## Variants difference declaration

We, Harman Automotive Electronic Systems (Suzhou) Co., Ltd. hereby declares that between H097 and H087, the difference is described as below content, other parts are identical.

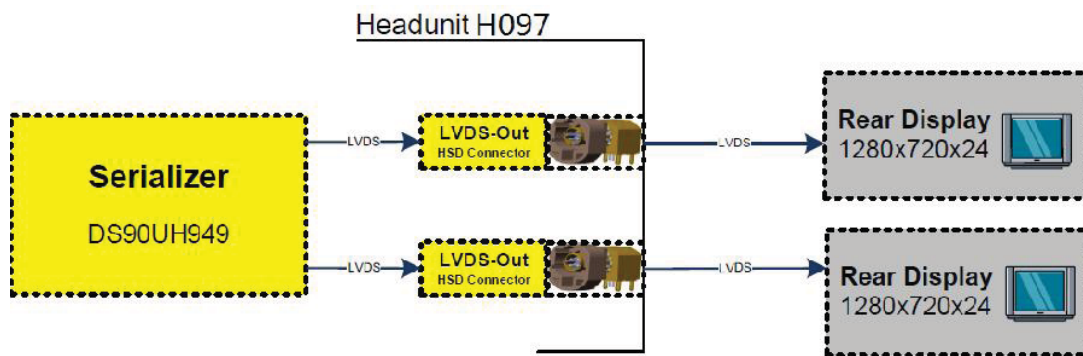
The components supporting the two rear displays are located on the main PCB 4110;

On this PCB 4110:

- In the H097, the LVDS serializer and the HSD connectors are assembled.
- In the H087, the LVDS serializer and the HSD connectors are not assembled.

Yellow parts are not assembled in the production of H087
